Requests for Clarifications And Responses

Order No. 754 – Data Request

The Study of Single Point of Failure

Revised: July 12, 2013

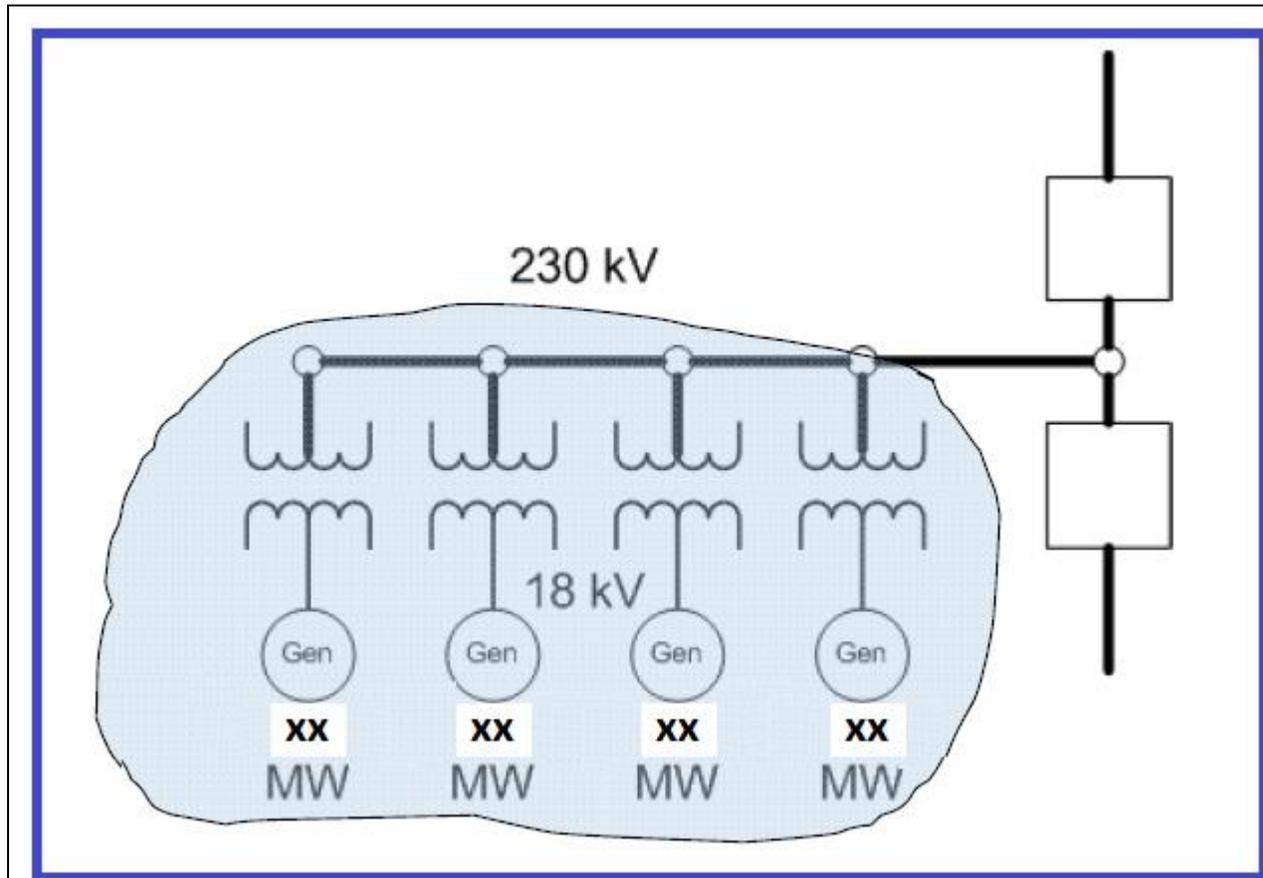
Step 1 Q1. In the example below, please provide guidance in regards to Table A of the Request for Data or Information. Would this generator collector bus with four GSU transformers that has one connection to the substation bus be counted as one GSU transformer or as four GSU transformers?

Step 1 A1. For the purpose of applying Table A it is necessary to determine the number of circuits connected to a bus. In this figure, the generator collector bus with four GSU transformers connected to the 230 kV substation bus via a single connection would be counted as one circuit.

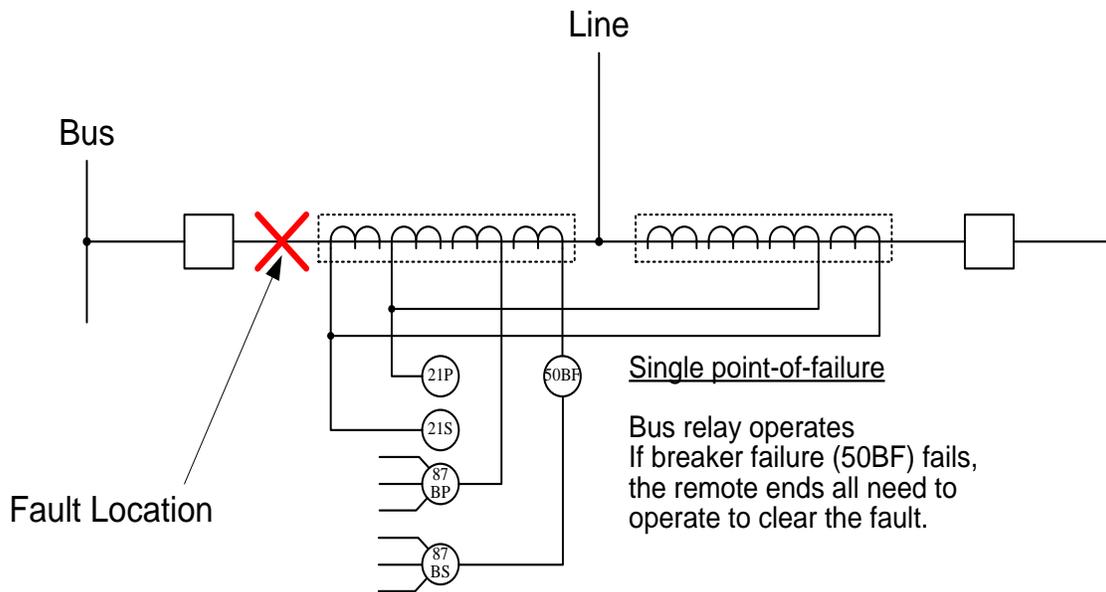
Table B, Q5. Please provide guidance on data reporting for facilities that utilize live-tank breakers and free-standing CTs. Unlike dead-tank breakers, this application does not provide the classic, over-lapping zones of protection and relies on the breaker failure protection for clearing a fault between the breaker and the free-standing CT. In the example below, the fault is in the bus protection zone; however, opening the bus breakers does not clear the fault and the fault remains outside the line protection zone. Generally accepted industry practice is to provide non-redundant breaker failure and CT column ground protection. Does this affect whether the bus and line protection systems meet the attributes in Table B?

Table B, A5. It is generally accepted in the industry that a fault in the location shown is a very low probability occurrence and it is standard industry practice to utilize one breaker failure relay and one CT column ground relay. The data request is not collecting information on this known condition, as it could skew the protection system attribute data being reported for buses, transmission lines, transformers, and shunt devices.
